**From:** Banks, Greg  
**Sent:** Friday, March 20, 2020 11:28 AM  
**To:** Donahue, Matthew  
**Cc:** Warner, David C.; Marsh, Lee  
**Subject:** RE: WSHB - Recommendation Update

West Seattle High-Rise Bridge – Updated Recommendations Additional Information

## Attachment 2: Teleconference Slides

Joint 38 South Box Nearest Pier 17 (Looking South at South Web)  
Photo date: 12/17/2019

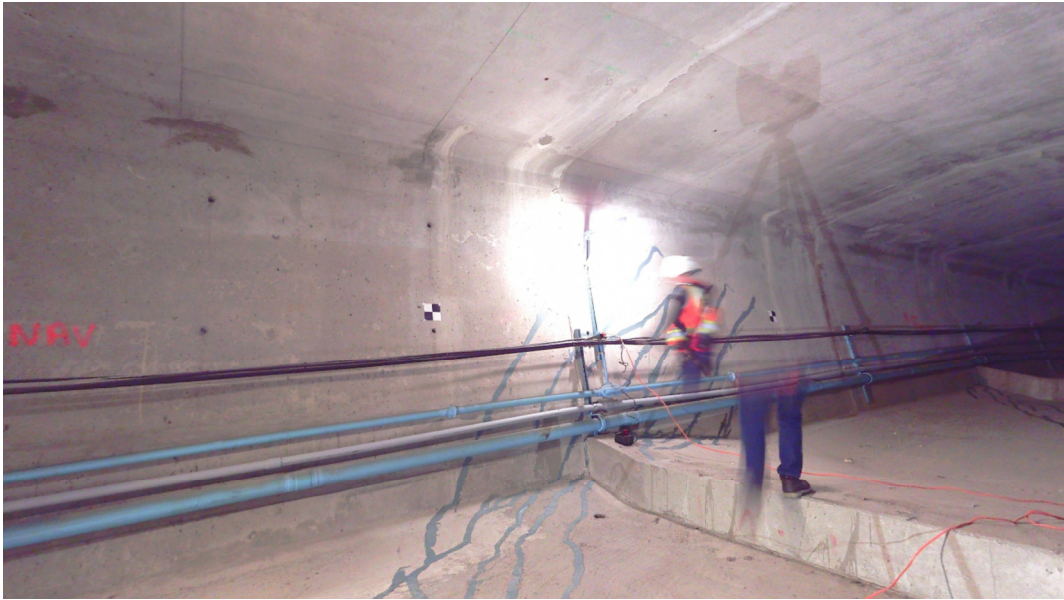
- In **October 2019** we could see evidence of cracks that had been marked in the past, but we could not define the extent of the cracks themselves.
- In **December 2019** we could see the all the cracks that had been previously marked, and observed that the cracks had extended beyond the previous markings. Cracks were traced with black marker to the extents that were observed. These extents were also marked with a date.
- In **March 2020** some of the cracks were observed to have again increased in length from what was observed in December 2020; approximately 6-inches to 12-inches further. The growth of the cracks were marked and dated with a black marker.

About the observations in March, not all the diagonal cracks have increased in length. From our review of the March inspection photos, the cracks that have increased in length appear to be those that terminate farther from the deck interface. This is an important observation. It indicates the joint is opening faster than we initially thought possible, which means the restraint provided by the rest of the structure is going away faster than we thought. Also, as cracking becomes more extensive, more load is transferred from the concrete to the reinforcing steel causing the structure to approach its full-strength capacity. Our analysis effort demonstrated that the strength of the bridge is very sensitive to this restraint and resulting “rotations” at the joint area created by the diagonal cracking. This is the fundamental reason of our heightened concern for the bridge.

Since this recommendation, we have come to learn that these cracks are not static, but that they are dynamic; they are extending, and if they continue to propagate, a failure could result. This requires a new recommendation, a recommendation to shut the bridge to operations now, and repair it immediately.
